**Addendum NO 2**

**DATE:**               April 26, 2022

**FOR:**                   **Pike County Bridge Replacement on C.R. 103 & C.R. 318.**

GRADING AND EROSION CONTROL PLAN

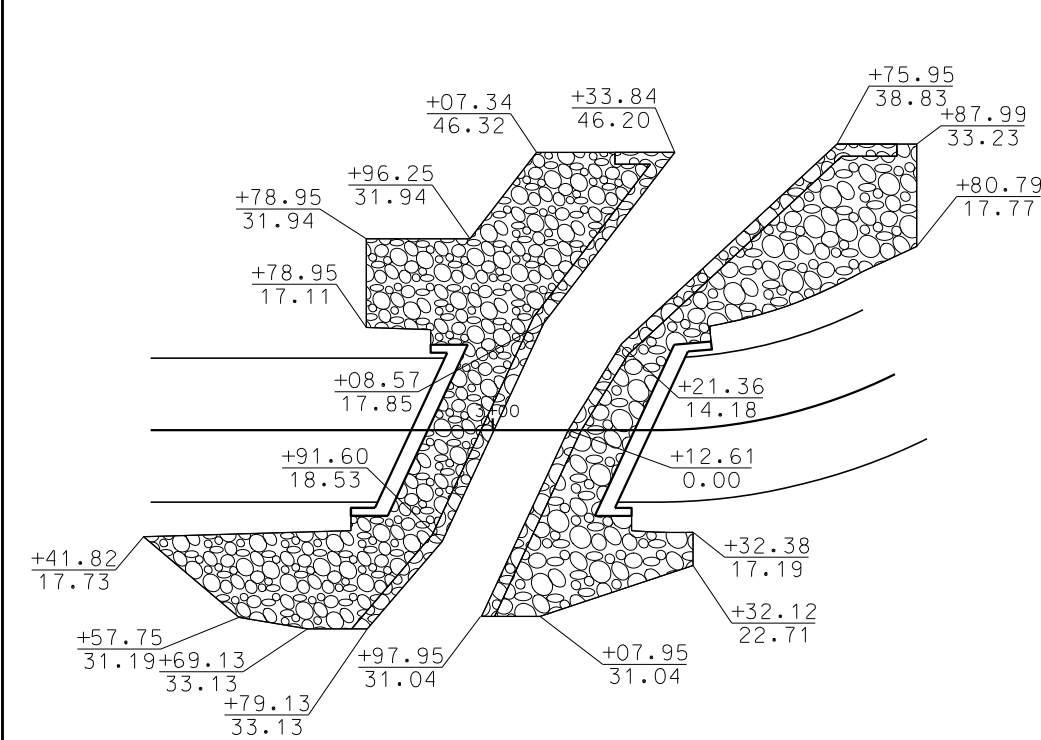
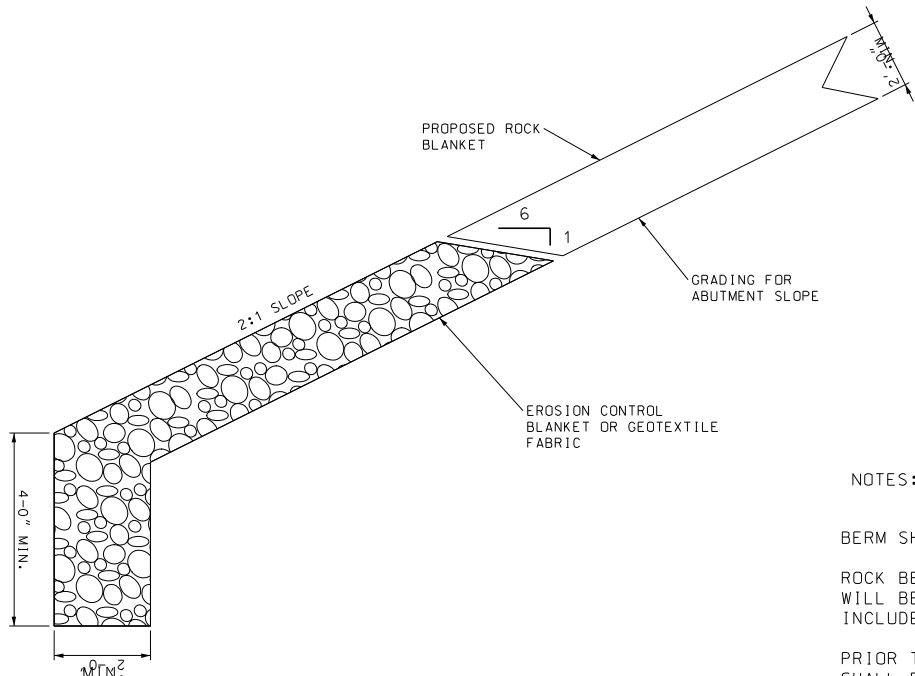
Sheet C4 –Added Fence and Fence note.

BERM SHALL BE BUILT TO HANDLE SIGNIFICANT RUN-OFF EVENTS.

ROCK BERM SHALL BE PLACED AT THE BEGINNING OF CONSTRUCTION AND WILL BE INCORPORATED INTO THE ROCK BLANKET. COST SHALL BE INCLUDED IN THE UNIT PRICE FOR THE TYPE 2 ROCK BLANKET.

PRIOR TO FINAL PLACEMENT OF TYPE 2 ROCK BLANKET, CONTRACTOR SHALL REMOVE GEOTEXTILE FABRIC AND ANY SILT BUILDUP ALONG TOP OF ROCK BERM. ALL WORK NECESSARY FOR REMOVAL SHALL BE INCIDENTAL TO BID ITEM TYPE 2 ROCK BLANKET.
